**Area Walk-By Checklist (AWC)**

Fermi 2 Seismic Walkdown Guideline  
Area Walk-By-Checklist

NJPR-12-0043

Detroit Edison, Fermi 2 Nuclear Plant  
TMPE-12-0294, Revision 0

(DSC 01357)

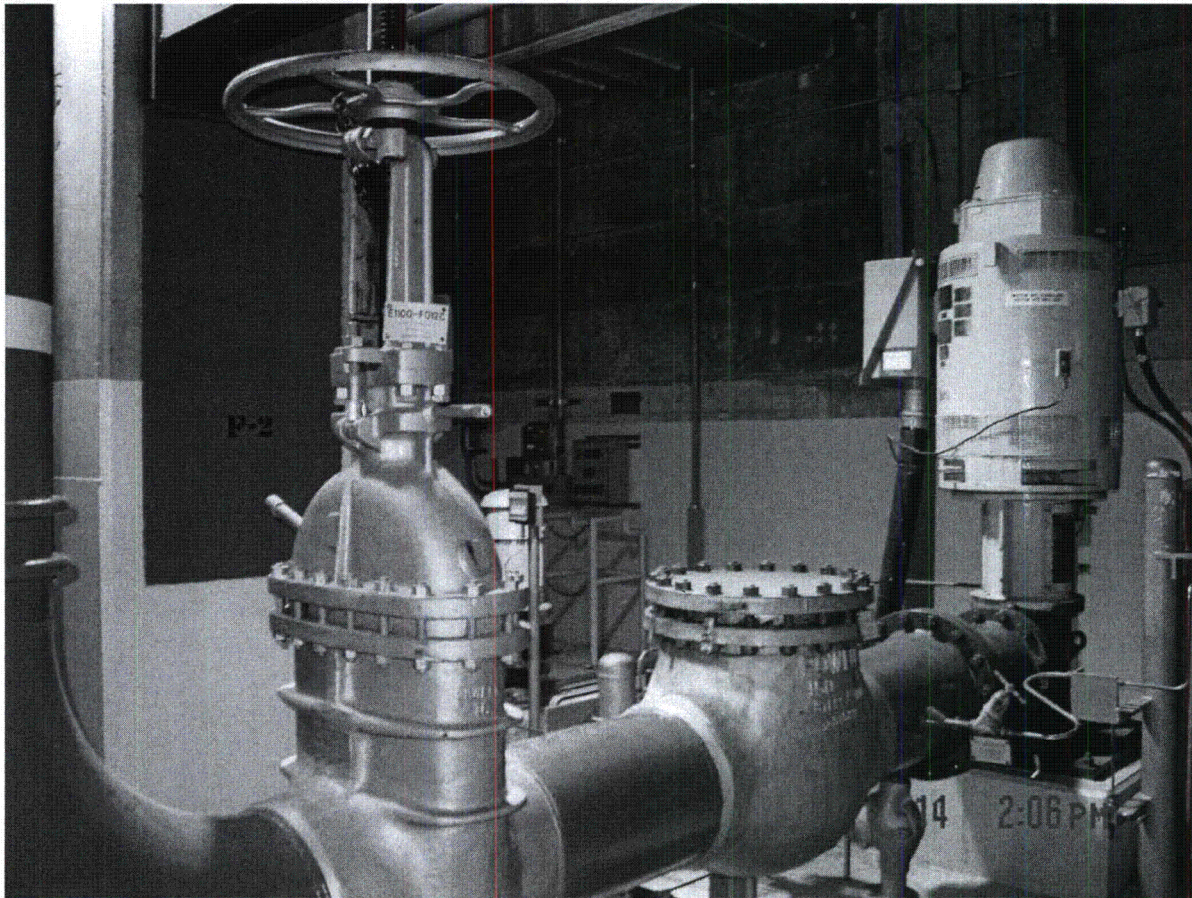
*There are no observed adverse seismic conditions. See photo DSC 01357.*

(DSCN 0389)

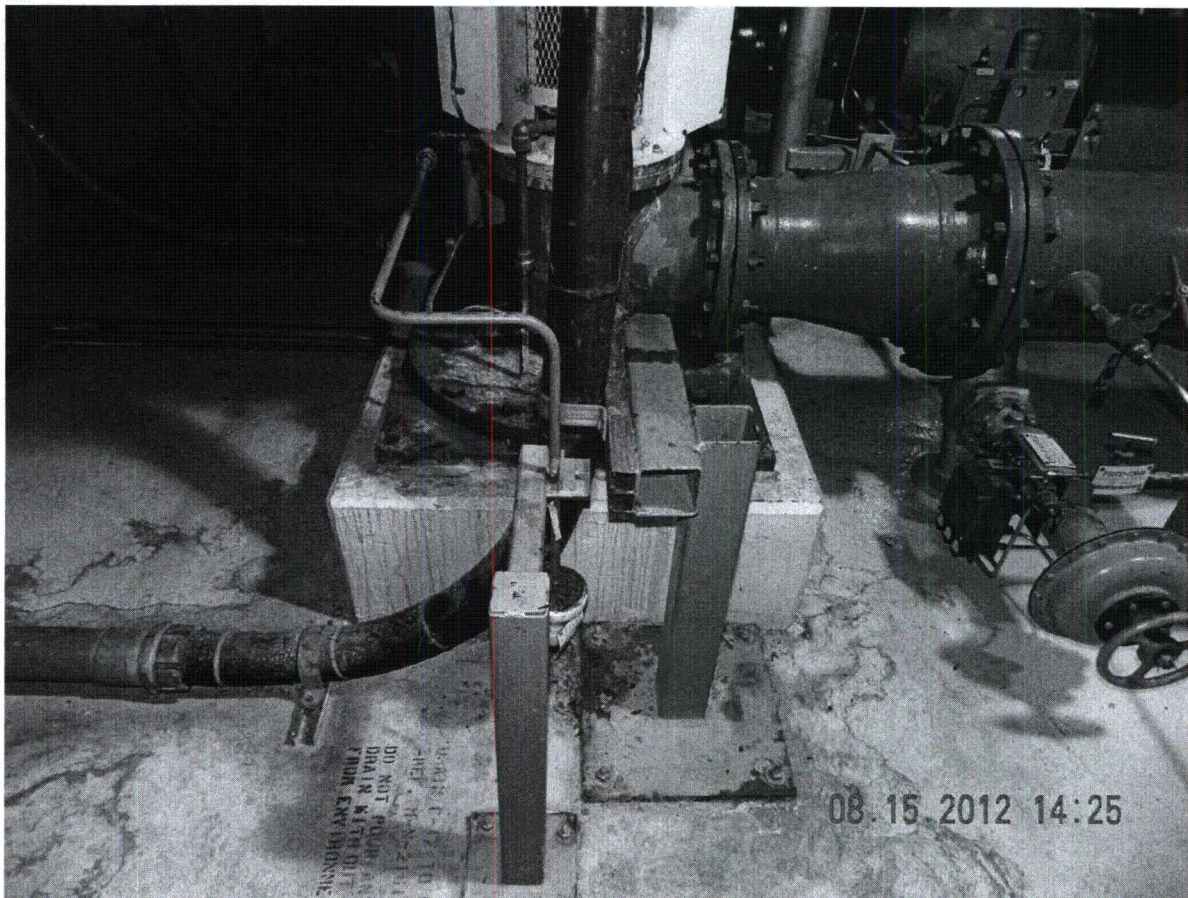
*Some stains and peeling paints, only minor corrosion. No loss of cross section. See photo DSCN 0389.*

(Picture 10)

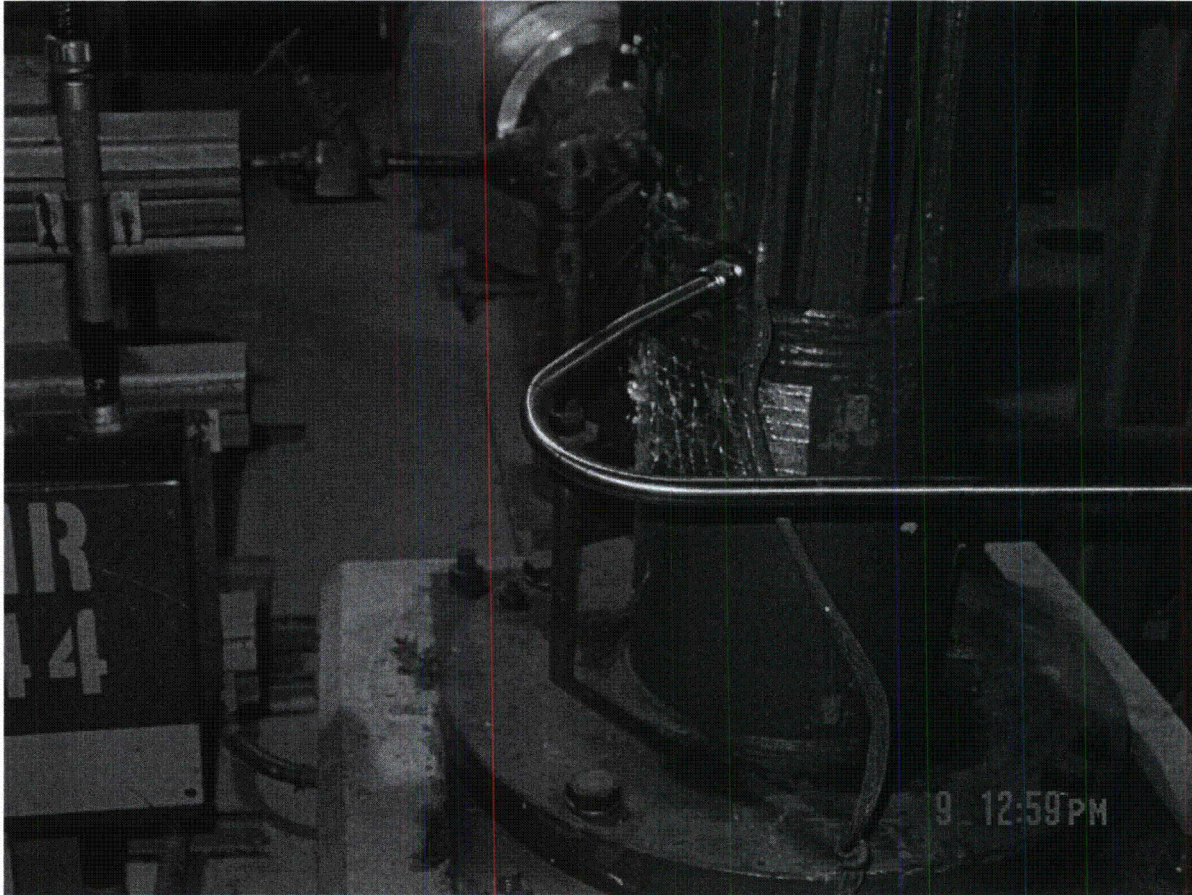
*All equipment nearby is adequately anchored.  
(See Picture 10)*

(DSCN 0529)

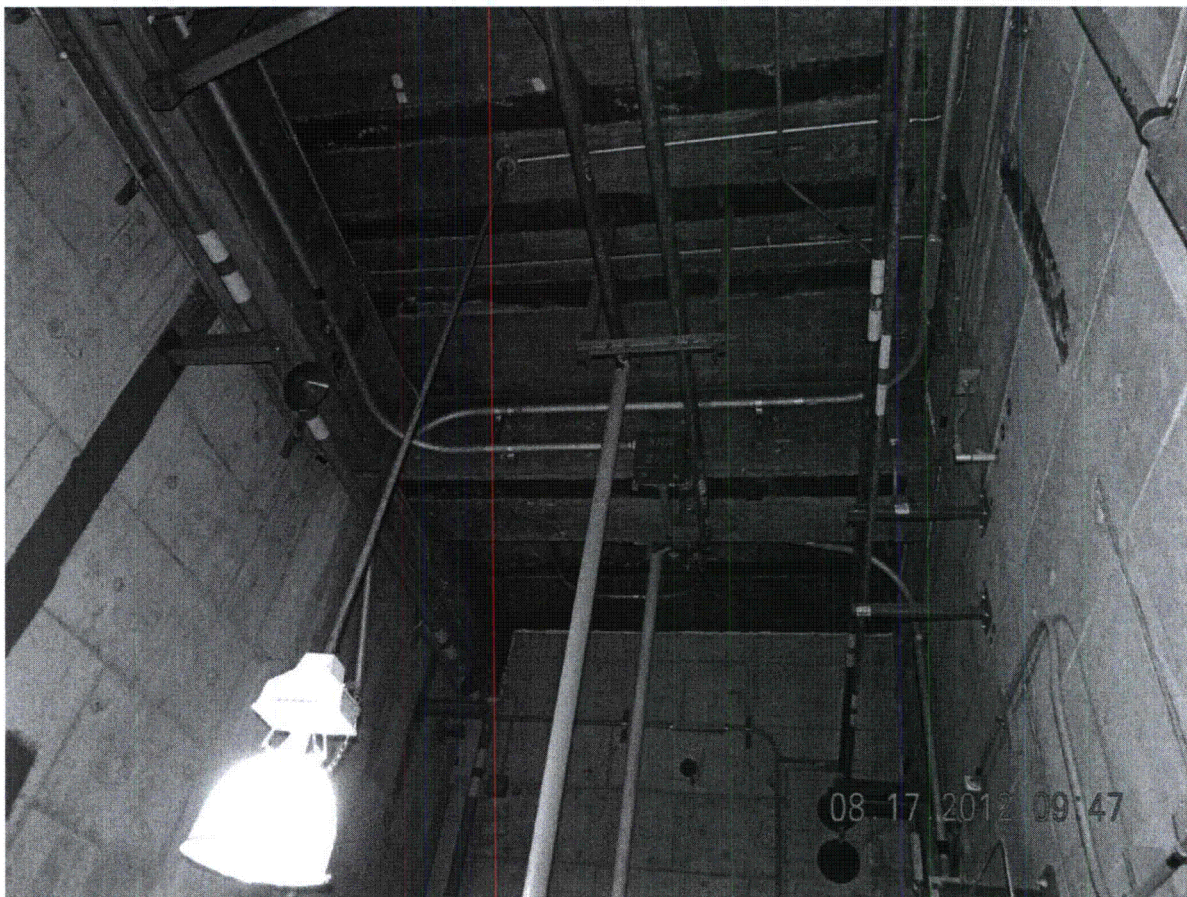
*No ceiling tiles in the area. Suspended lights are adequately secured. (see Photo DSCN 0529)*

(DSCN0535)

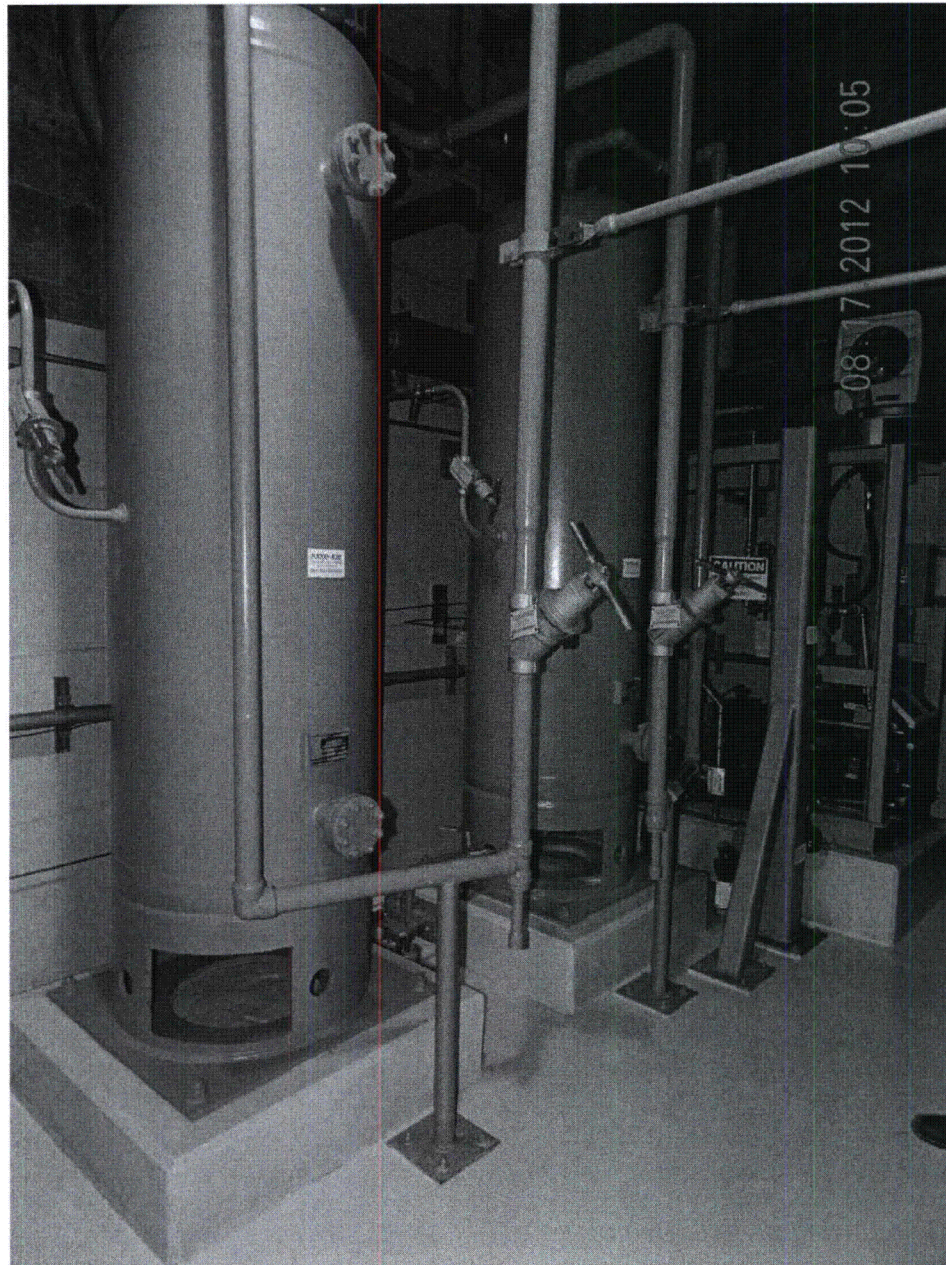
5. Does it appear that the area is free of potentially adverse seismic interactions that could cause flooding or spray in the area? Y  N  U  N/A   
*The area does not have fire protection piping or sprinkler system. CO<sub>2</sub> lines and other piping are adequately supported. No concern with flooding or spray in this area (see Photo DSCN 0535).*

(DSCN0538)

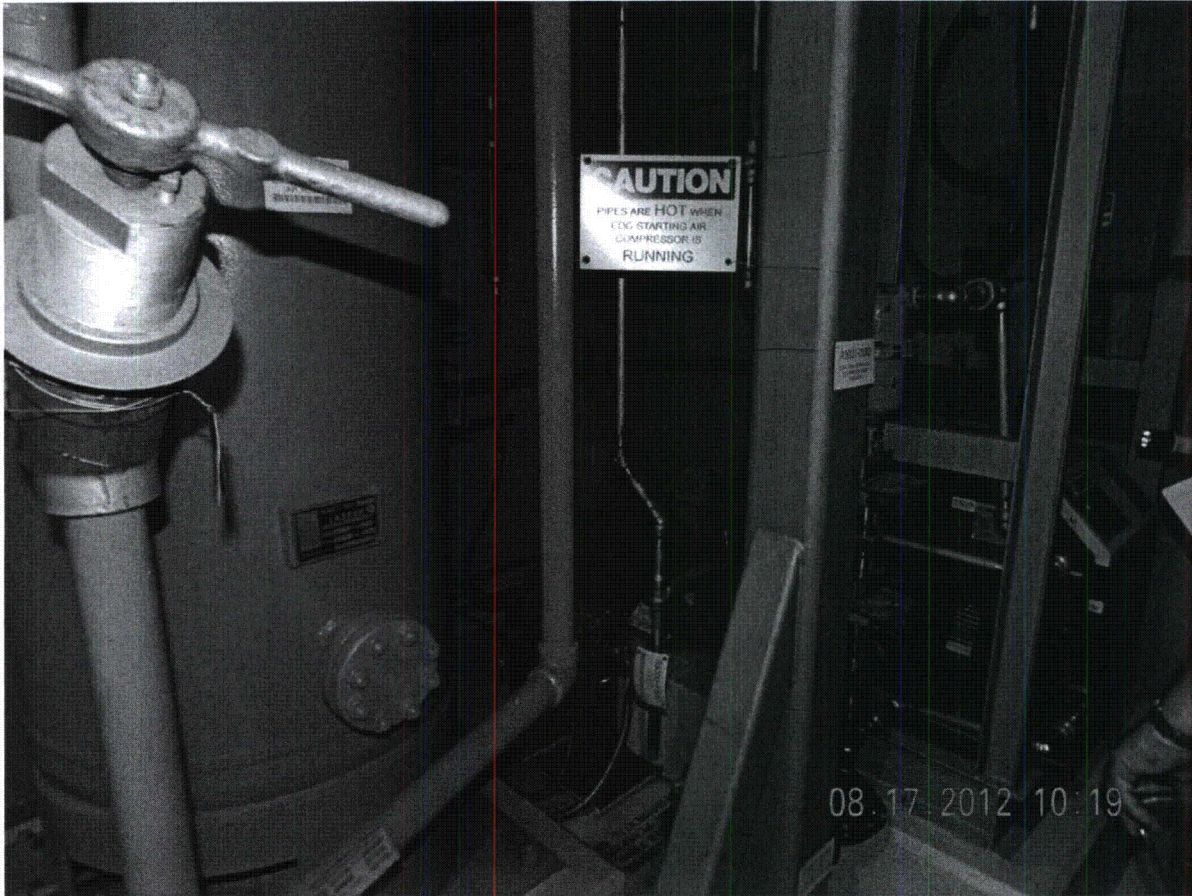
- 
8. Have you looked for and found no other seismic conditions that could adversely affect the safety functions of the equipment in the area? Y  N  U   
*No adverse seismic conditions found (see Photo DSCN 0538).*
-

(DSCN 0396)

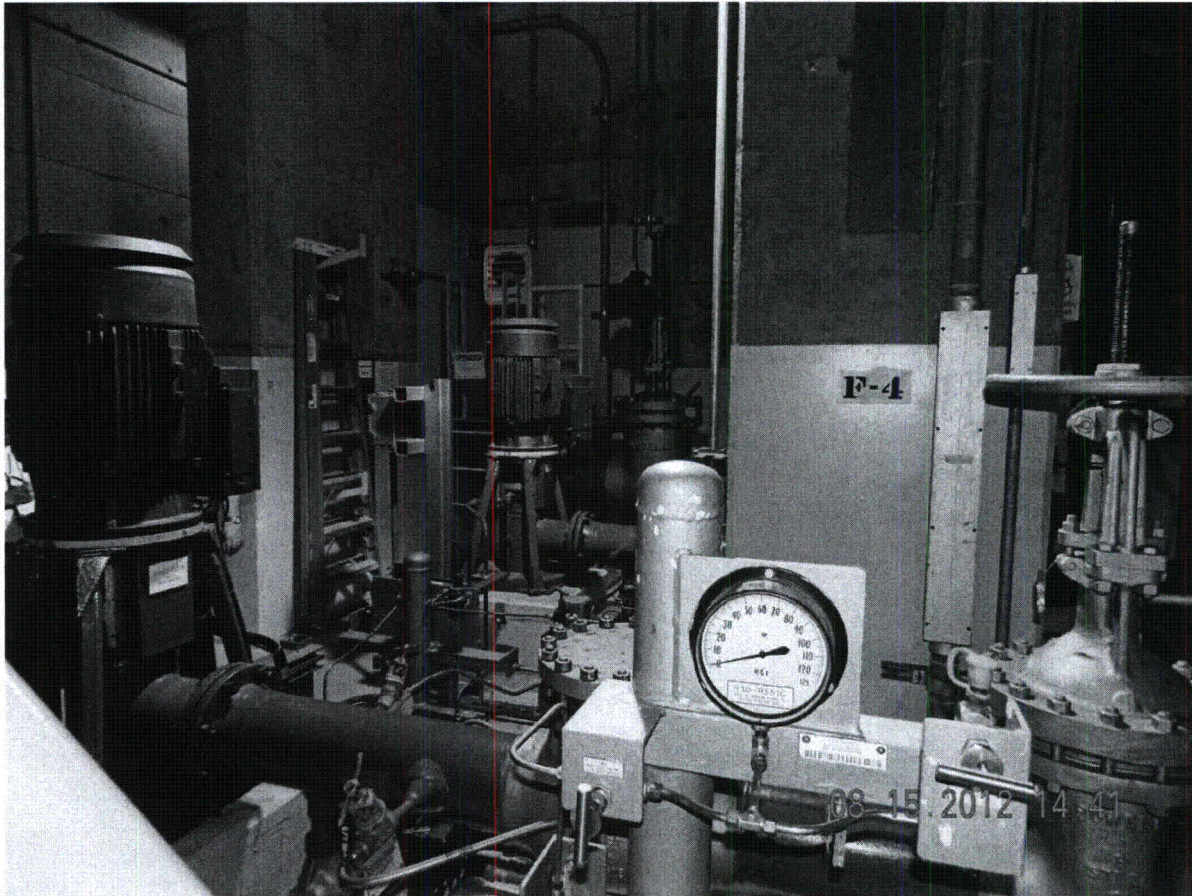
*Pump R3000C005 contains diagonal braces which do not appear on Vendor Dwg. MD-21144, Sheet 1, Rev. M. See Photo DSCN 0396. CARD 12-26977 was written to revise the vendor drawing to refer to hanger Dwgs. R30-C005-G01, Rev. 0, to R30-C008-G01, Rev 0.*
